Contract #: 04-0120F4
 Cty: SF/ALA Rte: 80 PM: 13.2/13.9
 File #: 69.25B

QUALITY ASSURANCE -- NON-CONFORMANCE REPORT

Report No: NCR-000828

Reference Description: West Tower Lift 2: Missed MT Crack on Skin B

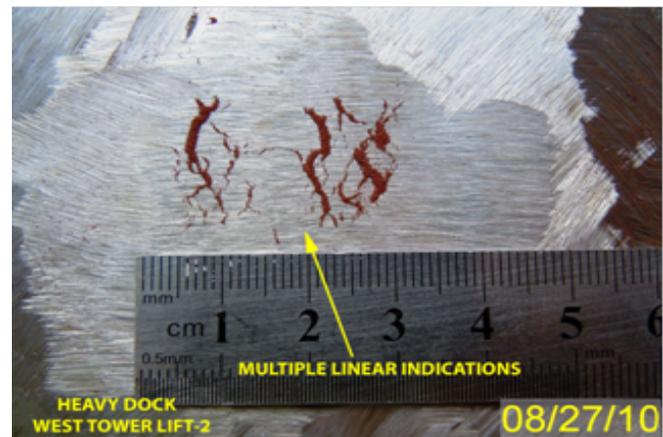
During Magnetic Particle Testing (MT) review of outstanding items on West Tower Lift-2, this Quality Assurance Inspector (QA) discovered the following issue:

- Cracks found on base material of Skin 'B' external side.
- Location: West Tower Lift-2 Skin 'B', 4380 mm from top of the tower and 560 mm from Skin B/C corner.
- This member is Non-Seismic Performance Critical Member (non SPCM).
- This member is located at the Heavy Dock area.

The Notice of Witness Inspection Number (NWIT) is 006494. These cracks are located inside the area that has been previously tested and accepted by ZPMC Quality Control (QC) personnel. ZPMC's QC personnel performed 100% MT inspection of these welds.

AWS D1.5 (02) Section 6.26.2 – “Welds that are subject to MT in addition to visual inspection shall have no cracks.

Reference Resolution: ZPMC has repaired the indications and is providing the repair report and NDT performed after to show it is acceptable.

This proposed resolution is accepted with action pending. This NCR will be considered closed once the proper NDT documentation is submitted and reviewed.

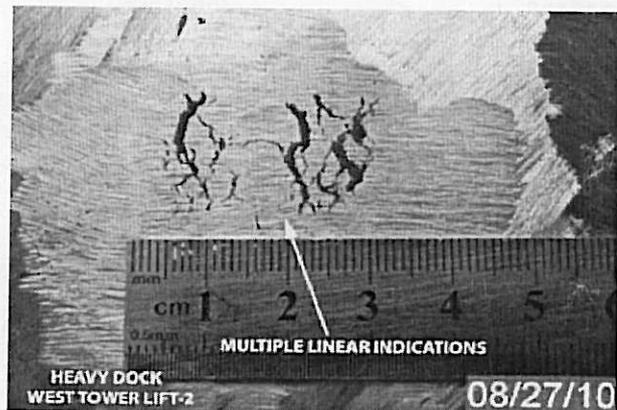
-Cracks found on base material of Skin 'B' external side.

-Location: West Tower Lift-2 Skin 'B', 4380 mm from top of the tower and 560 mm from Skin B/C corner.

The Notice of Witness Inspection Number (NWIT) is 006494. These cracks are located inside the area that has been previously tested and accepted by ZPMC Quality Control (QC) personnel. ZPMC's QC personnel performed 100% MT inspection of these welds.

Draft of welding discontinuity:

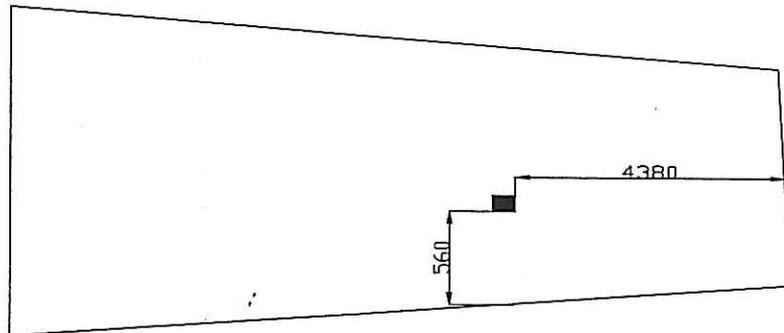
西塔二吊B面板在报加州冲砂后的返修点时发现一裂纹，长30mm宽10mm深5mm具体如图：
West tower 2nd lifting Skin B, the crack was found after sanding; 30mm in length, 10mm in wide, 5mm in depth, and the details sees the following draft.

1. 火焰加热时, 水汽没有完全的去掉或者这个区域预热不够;
1. Moisture wasn't completely removed during drying operation (preheating) or the area wasn't preheated sufficiently.

Remark: repair area in shadow.

- 1、 Grind smoothly the defect area
- 2、 If User's request ,check with VT or other NDT method to make sure the defect remove completely;
- 3、 Preheat and weld passes temperature according to the approved WPS, it should be 2-3mm than the theory size;
- 4、 Grind the weld area smoothly;
- 5、 Perform NDT of the repair area.
